No.	Date	Revision/Issue
	12/08/08	DSA SUBMITTAL
	02/11/09	DSA SUBMITTAL
	5/11/09	DSA BACKCHECK
	12/15/2011	BID SET
1A	12/16/2011	ADDENDUM 1A

MUIR FUNDAMENTAL SCHOOL MODERNIZATION

BUILDING 2 REMODEL PLAN

P2.2

BUILDING 2 - REMODEL PLAN 1/8"=1'-0" 1

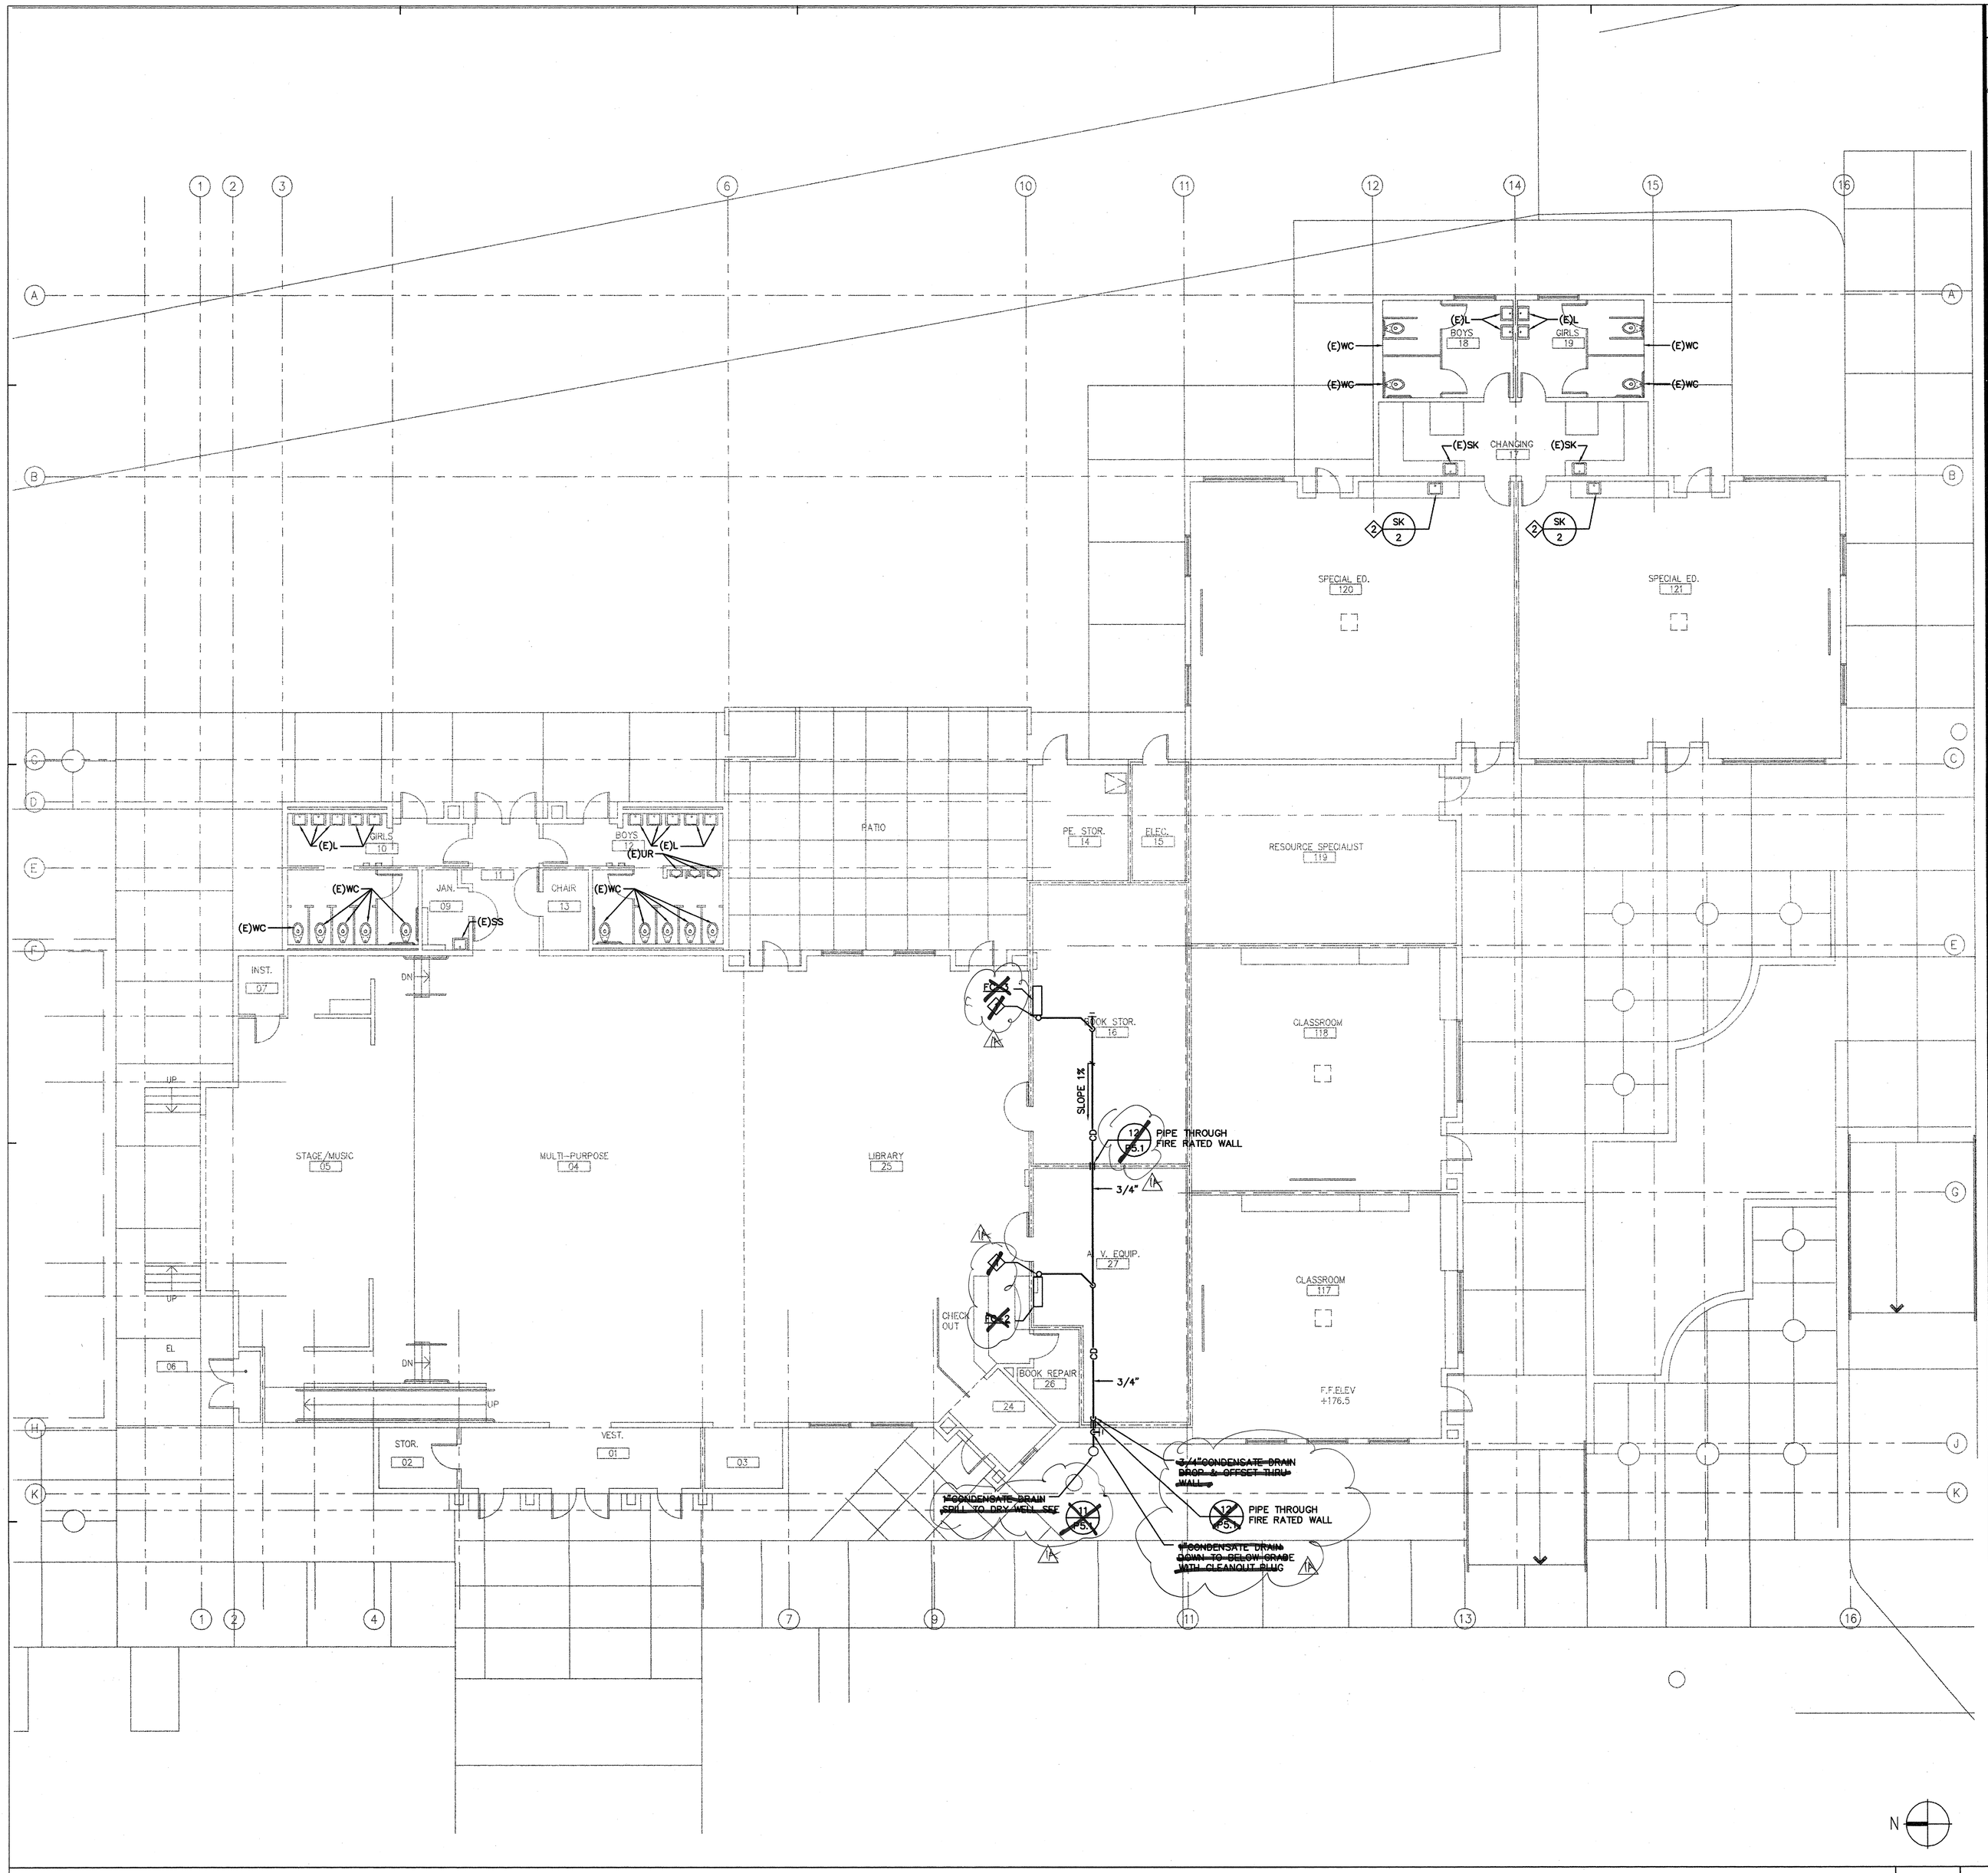
1. ~~3/4"CONDENSATE DRAIN CONNECT TO FAN COIL UNIT PUMPED CONDENSATE AND ROUTE ABOVE CEILING. SEE MECHANICAL DRAWING FOR EXACT LOCATION~~
2. INSTALL NEW ACCESSIBLE SINK, FAUCET. CONNECT WASTE AND WATER TO MODIFIED UTILITIES AT WALL.
